METRO HEADQUARTERS

PROJECT MEETING MINUTES

RE: Response to METRO Headquarters Plancheck Comments
Application #20180A

<p>THOMPSON VAMODA & ASSOCIATES ARCHITECTS AIA</p> <p>1010 SOUTHWEST ELEVENTH PORTLAND, OREGON 97205 TELEPHONE: (503) 220-0644</p>	METRO HEADQUARTERS		Scale 1/8"	Drawn by PT
	STAIR #2 GATE AND 2 EXIT LIGHTS		Project No. 91025	Drawing No. A51-11
	REFERENCE A3.7		Date 6/12/92	1

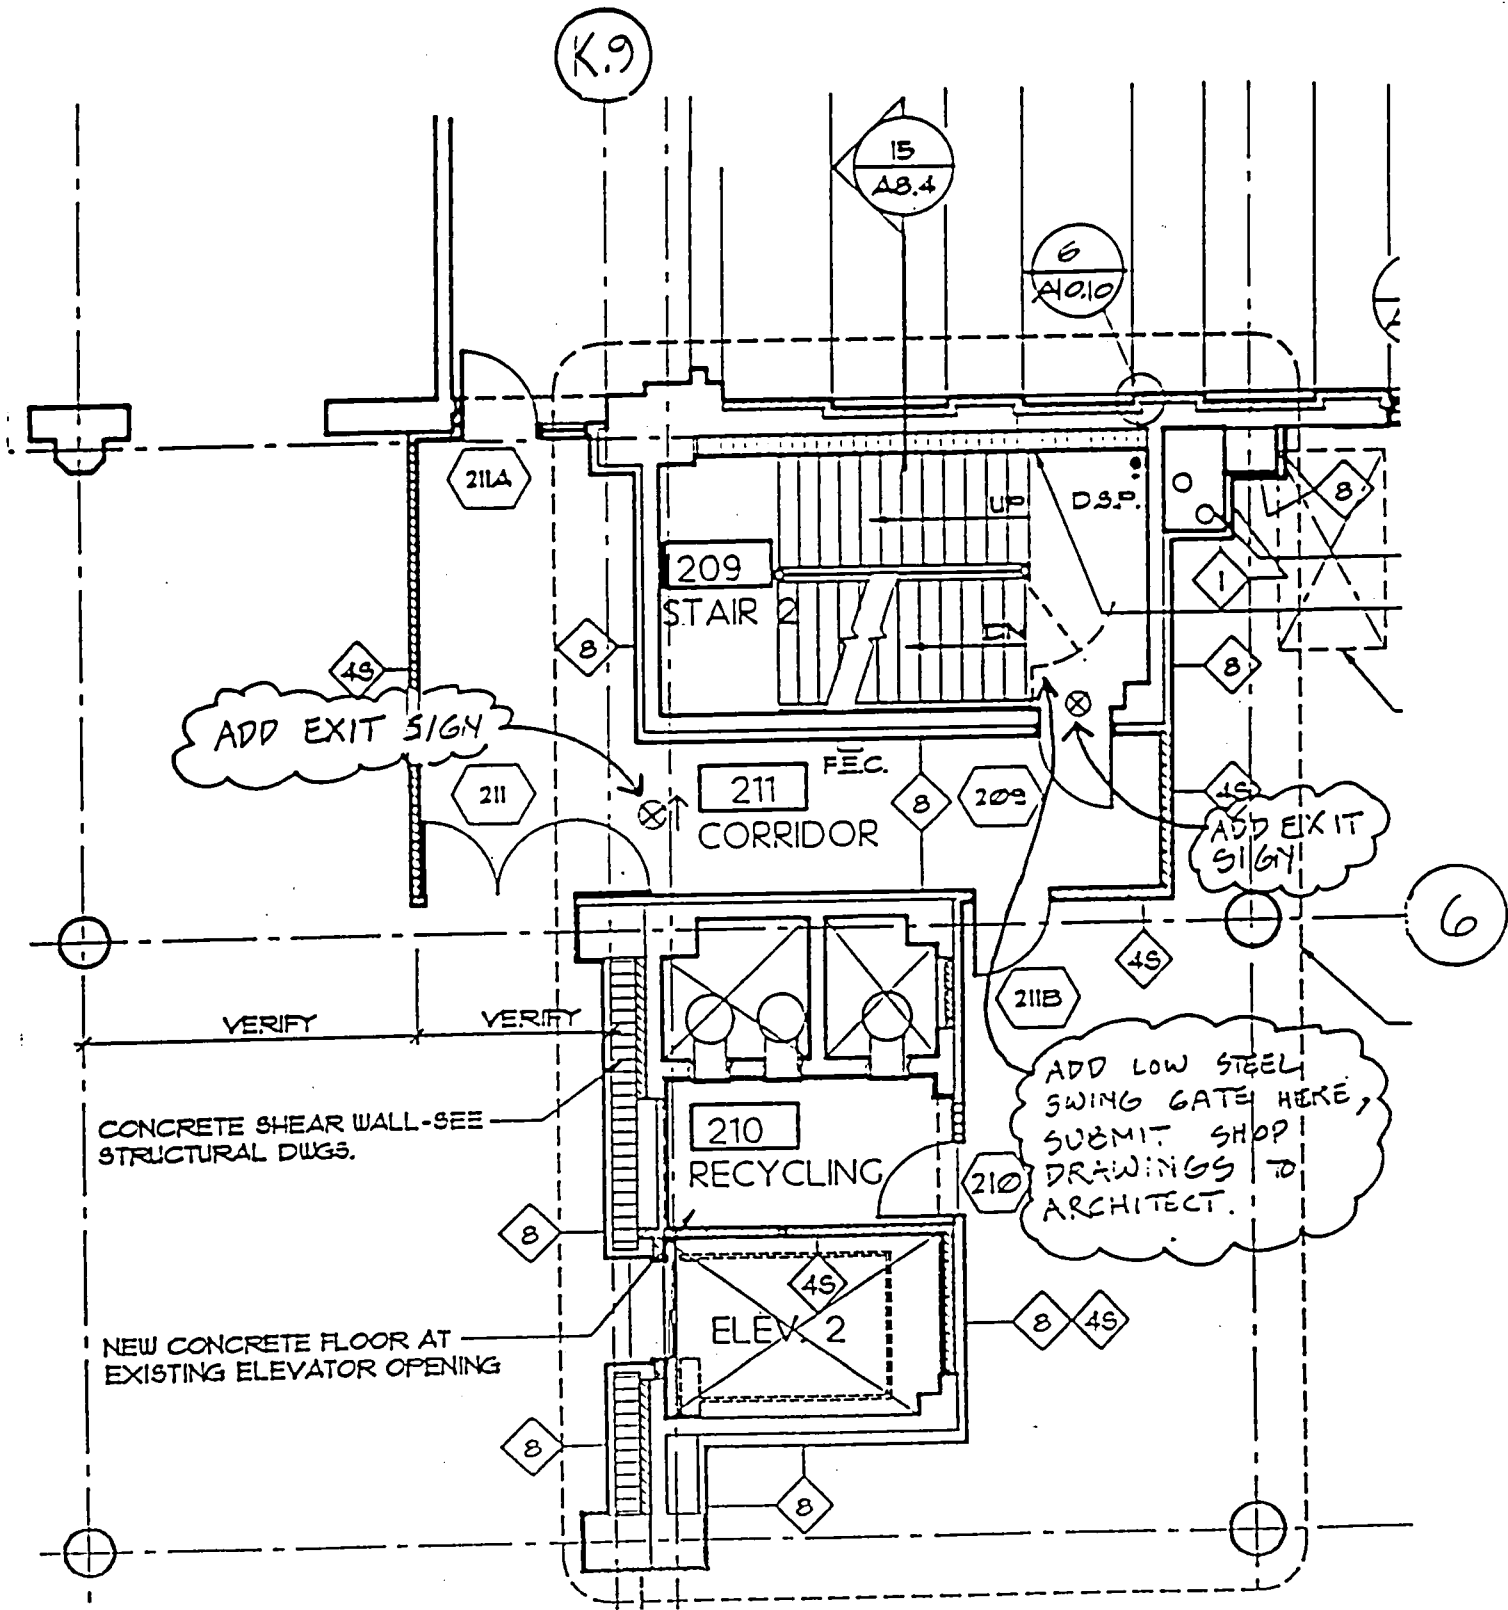
- 6/A6.4, 4/A10.12, 5/A10.12, and on 20/A10.12 change only the handrail pipe size but keep the additional guardrail pipe at the 2" dimension.
- Item 8 We will add the low swing-gate barrier at the second floor level at stair #2 as per attached drawing ASI-1. This drawing will also be pasted into the (3) permit sets and has been issued to the Contractor.
We will also add one illuminated exit sign directly over door #209 on the stair side and another sign in corridor 211 directing towards the exit door #211A. This will be marked-up on the plans by GLUMAC.
